**REQUEST FOR BIDS
FOR
CONSTRUCTION
FOR
CVAG OFFICES - TENANT IMPROVEMENTS PROJECT
PROJECT NO. CV-2026-TIP-01**

ADDENDUM

Addendum Date: May 20, 2026

**CVAG Offices – Tenant Improvements Project (TIP)
Project No. CV-2026-TIP-01**

Project Status
A2.20

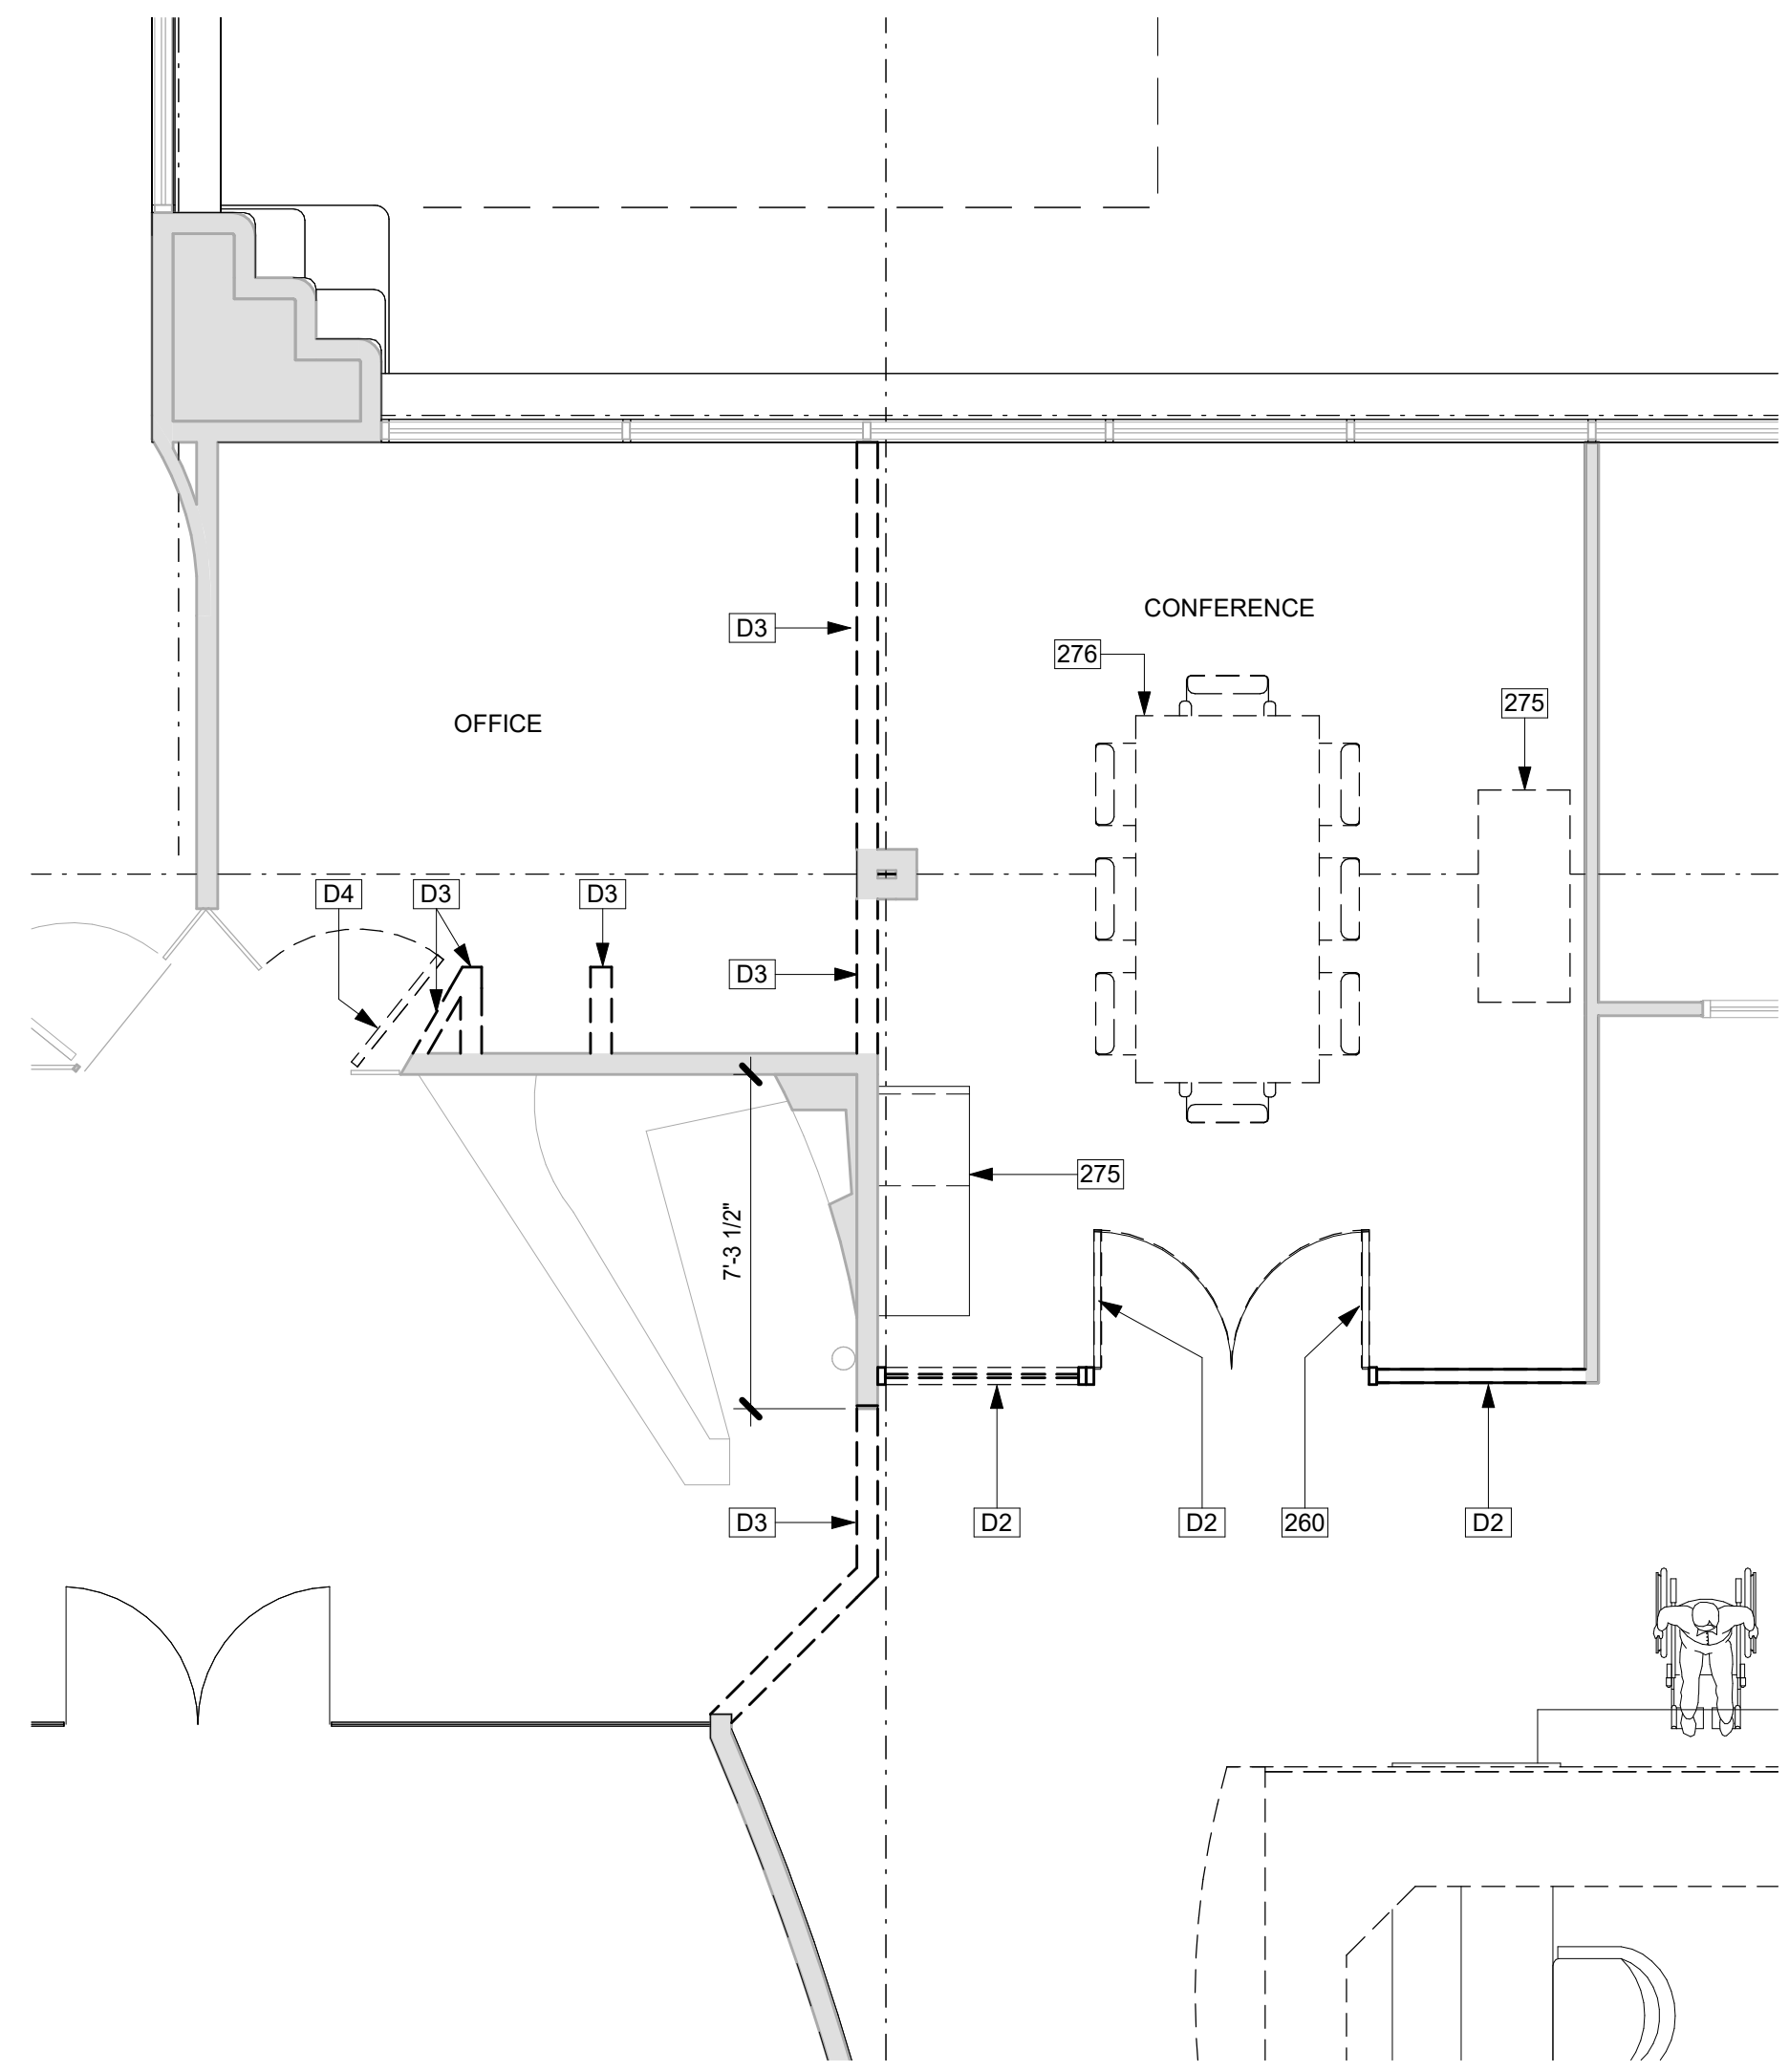
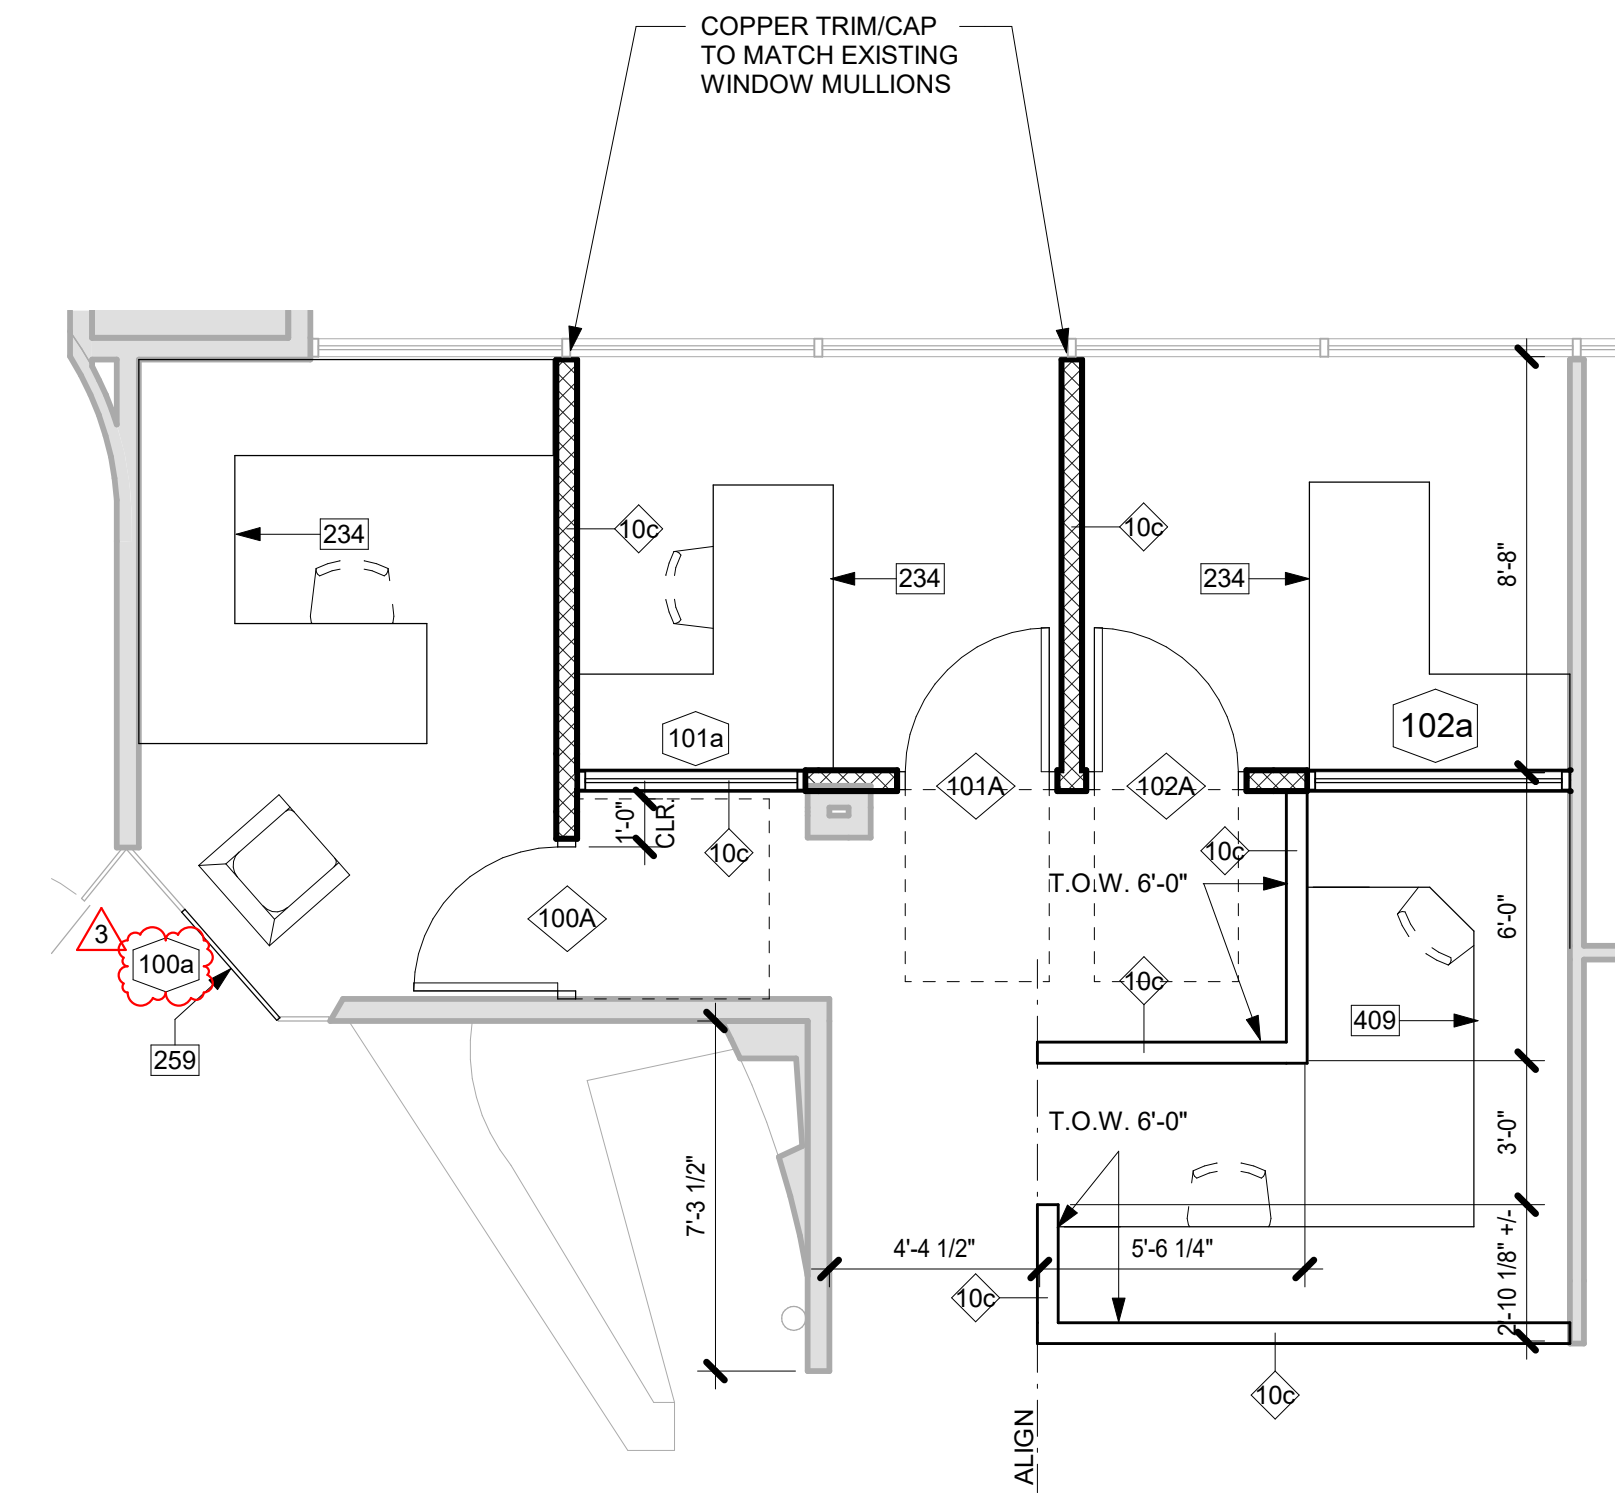
7. **Question:** Per plans, Phase 1 - Door 110A at the phone room is re-used from demo in Phase 2. Are they good with not having a door at the Phase 2 location during Phase 1? Please provide door trim finish specs.

8. **Question:** Please confirm all new and reused doors, glazing panels, borrowed Lites, infill storefront/glass panels, frames, and hardware are fully scheduled, and provide any missing frame elevations/details.

Response: *Door 110A is no longer a reused door, it is now a new door. Reference Delta-3 on sheets A2.21, A2.24, & A7.10. Contractor to perform a site visit to verify door trim finish specs, as all new doors are to match existing.*

Response: *Missing window 100a has been added to sheet A2.20 & A7.10.*
